BID ADDENDUM NO.1

Issue Date: February 5, 2021

Project: Leavenworth City Hall – Parapet / Building Repair Project
100 North 5th Street,
Leavenworth, Kansas 66048

CITY HALL
NORTH RAMP IRRIGATION

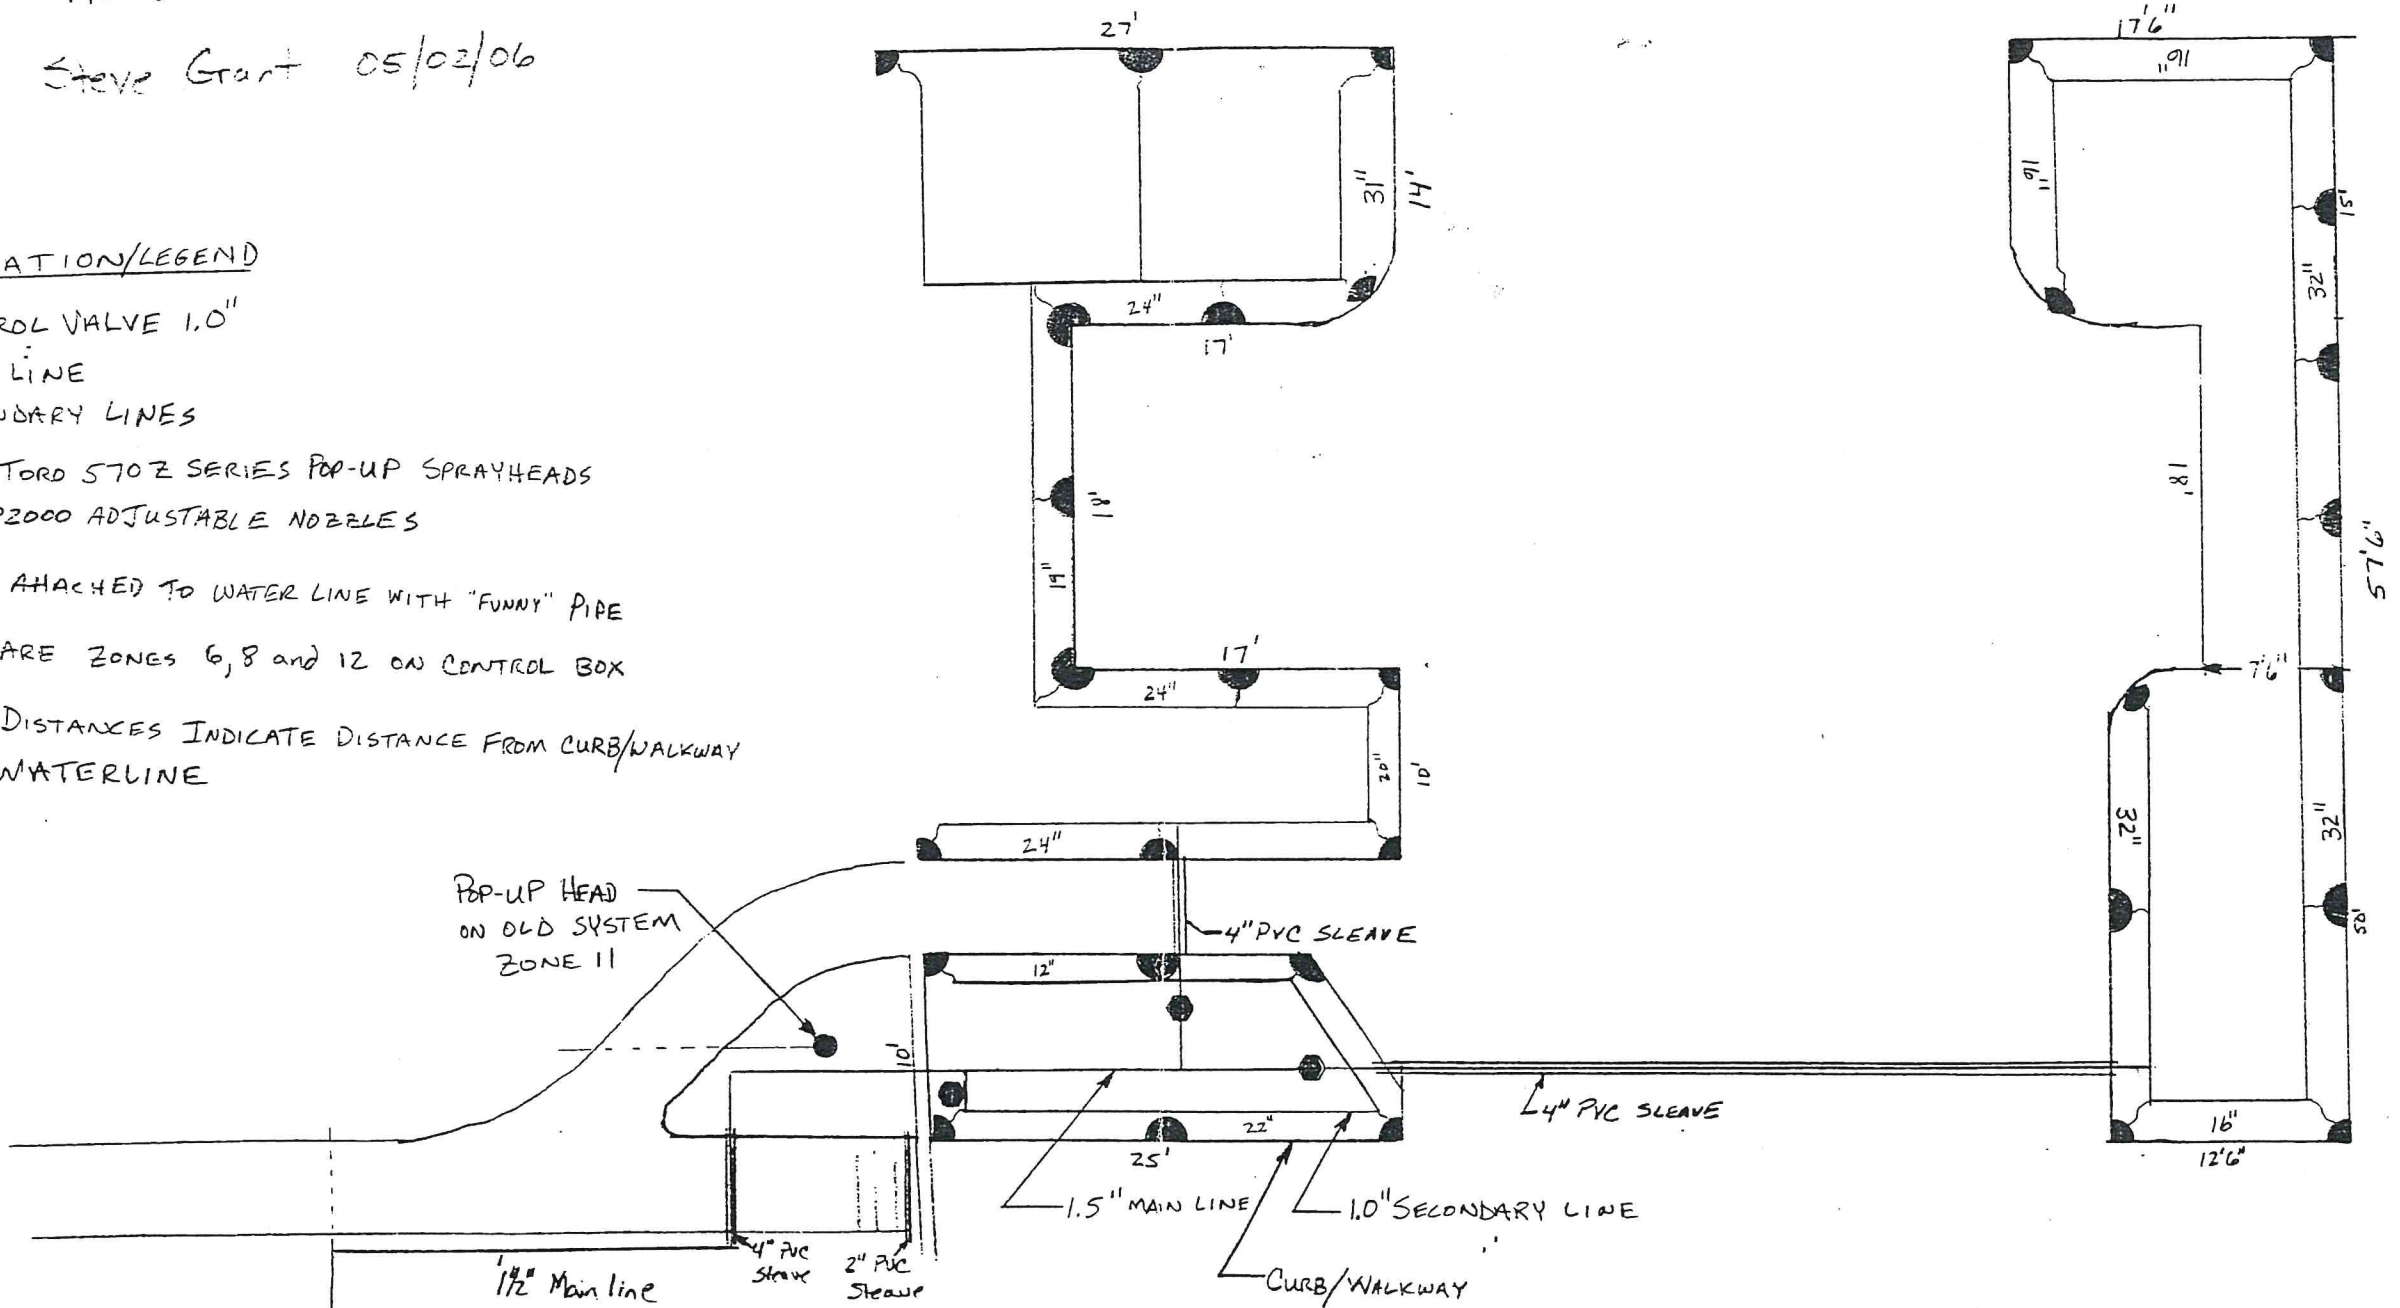
- Adjust sprinkler heads adjacent to statue base which are directed towards the stone to prevent over spray statue base which has led to stone deterioration. Note, this may require an alternate sprinkler head in these locations rather than just redirecting the head. Note: a drawing provided by the City of Leavenworth for the current layout of the irrigation system is enclosed at the end of this document.
